APPLICATION NUMBER 11 & 12 DATE January 8, 2003

APPLICANT Norstedt Subdivision

REQUEST Planned Unit Development, Subdivision

# SITE PLAN

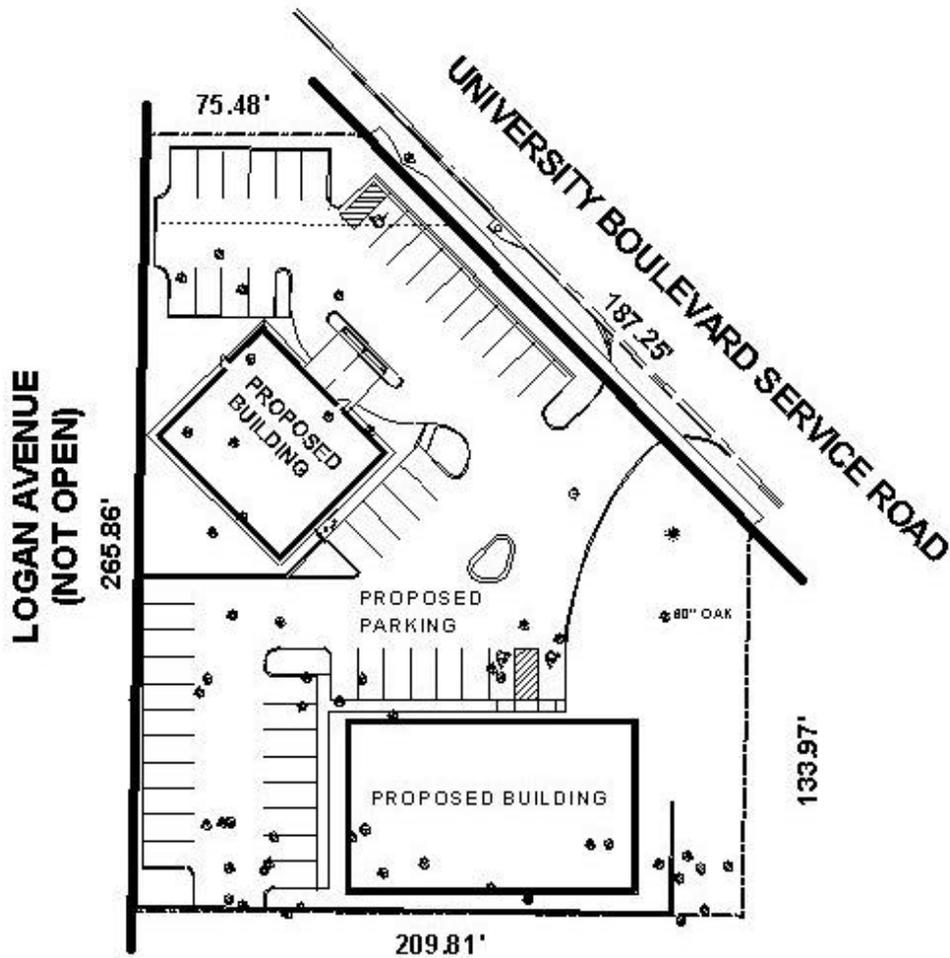
The first relates to the location of the building along the Southern lot line. The Zoning Ordinance requires a minimum 10' buffer strip when commercial property abuts residentially zoned property. As proposed, the building will be 6.78' from the property line. While PUD approval may allow reduced setbacks, it should not be used to reduce buffering requirements. In addition, as parking facilities are proposed in a portion of the required buffer strip, a 6' wooden privacy fence should also be provided along the South and East property lines.

Another point relates to the unopened Logan Avenue right-of-way adjacent to the West. This unopened right-of-way is an issue for two reasons. The first relates to setbacks. As proposed, one of the buildings is less than 5' from the Logan Avenue property line. The Zoning Ordinance requires a minimum setback of 20' from a side street property line when the property to the rear fronts on the side street.

The Subdivision now before the Commission does not reflect the vacation of the Logan Avenue right-of-way or the 7' alley. However, a vacation request for Logan Avenue has been submitted to the City and includes right-of-way South of the site in question. As submitted, that request has been recommended for denial because it would create a landlocked property (the lot immediately South of the property in question). Therefore, completion of the vacation process for the portion of Logan Avenue adjacent to the site should be required. Also, as the remaining portion of Logan Avenue would serve residential properties, access from this commercial development to Logan Avenue should be denied.

**RECOMMENDATION**      **Planned Unit Development:** based on the preceding, it is recommended that this application be approved subject to the following conditions: 1) completion of the Subdivision process prior to the issuance of any permits; 2) provision of the required 10' buffer strip along the South property line, and a 6' wooden privacy fence along the South and East property lines – where the site abuts residentially zoned properties; 3) completion of the vacation process for the portion of Logan Avenue that abuts this site; 4) the 60" Live Oak on the East side of the property (University Boulevard Service Road) is to be given preservation status (Any work around, including trimming or removal of this tree, requires approval from the Mobile Planning Commission.), all work under the canopy is to be permitted and coordinated with Urban Forestry; and 5) full compliance with all municipal codes and ordinances.

**Subdivision:** based on the preceding, the plat is recommended for Tentative Approval subject to the following conditions: 1) provision of the required 10' buffer strip along the South property line, and a 6' wooden privacy fence along the South and East property lines – where the site abuts residentially zoned properties; 3) completion of the vacation process for the portion of Logan Avenue that abuts this site; 4) placement of a note on the final plat stating that access to Logan Avenue is denied; and 5) placement of a note on the final plat stating that the 60" Live Oak on the East side of the property (University Boulevard Service Road) is to be given preservation status (Any work around, including trimming or removal of this tree, requires approval from the Mobile Planning Commission.), all work under the canopy is to be permitted and coordinated with Urban Forestry
